**Evaluation of the Environmental and Social Impact Assessment (ESIA)  
for the Oyu Tolgoi Copper and Gold Project**

Prepared by:

**October 2012**

**Figure 5.22: Water Losses as a Percentage**

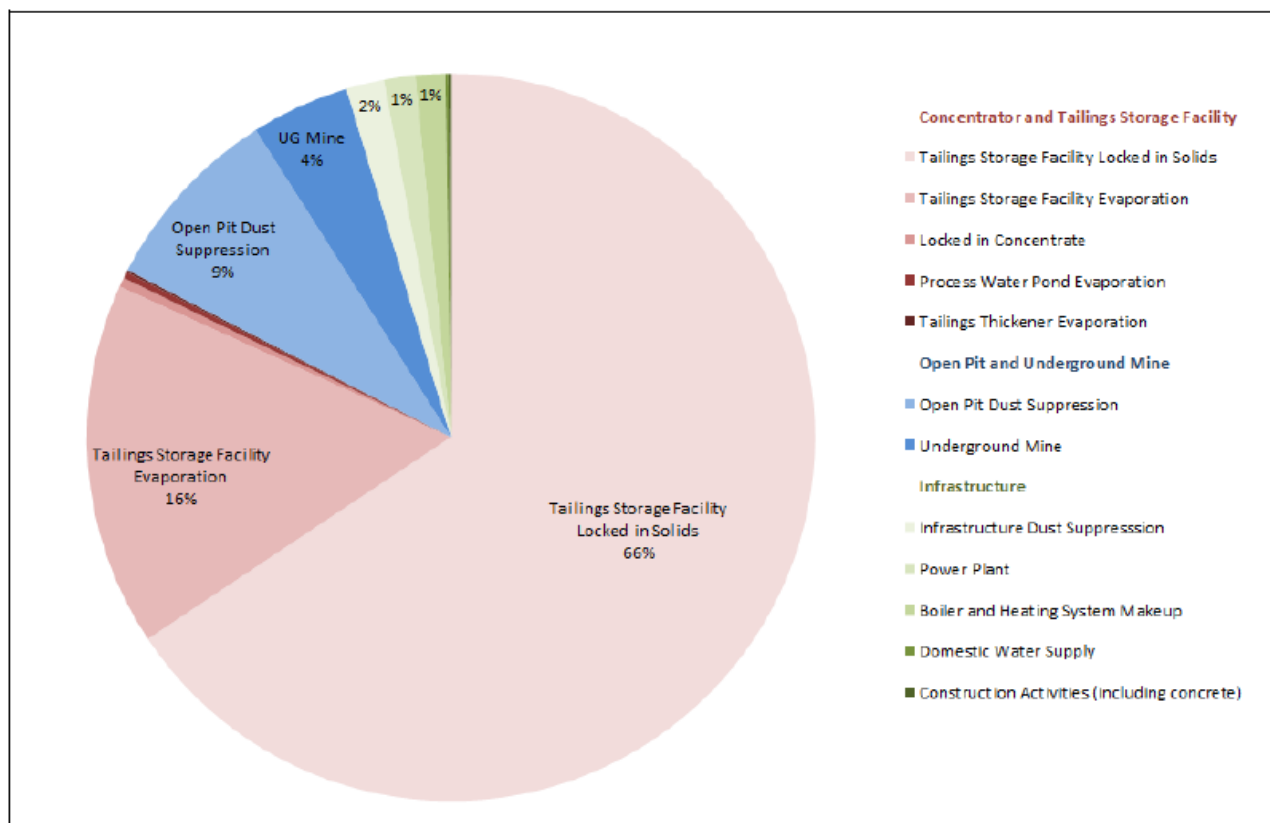
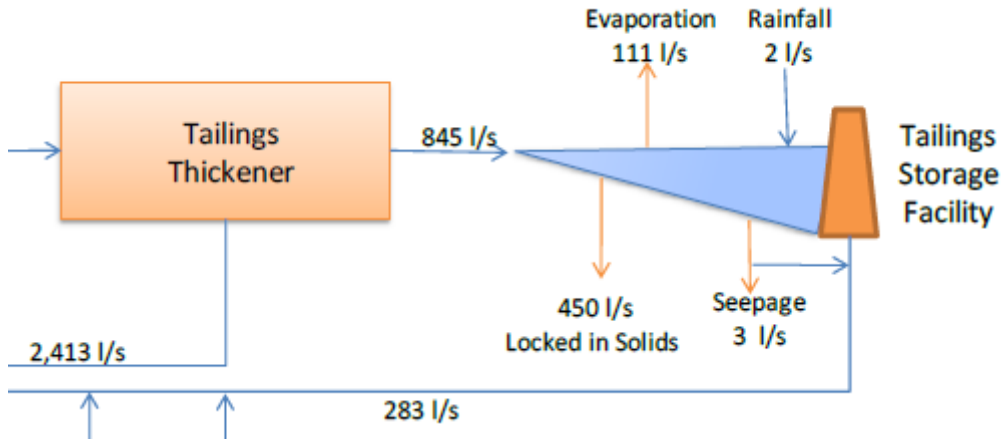
First, employing dry tailings disposal would greatly reduce the project’s water demand. Figure 5.22 on page 55 of Chapter C5 of the ESIA shows that over 80% of the project’s water losses will be associated with the choice of conventional tailings disposal and the associated tailings storage facility (see following page). Figure 5.23 of the ESIA on the following page of the ESIA shows that 450 liters per second would be locked into wet tailings and a further 111 liters per second would be lost from the wet tailings impoundment by evaporation.

What is so significant about these figures is that the combined losses from the tailings storage facility of 561 liters per second represents over 90% of the proposed groundwater abstraction for the project (620 liters per second). If water scarcity is a concern for this project, then the option of dry tailings disposal is an imperative.
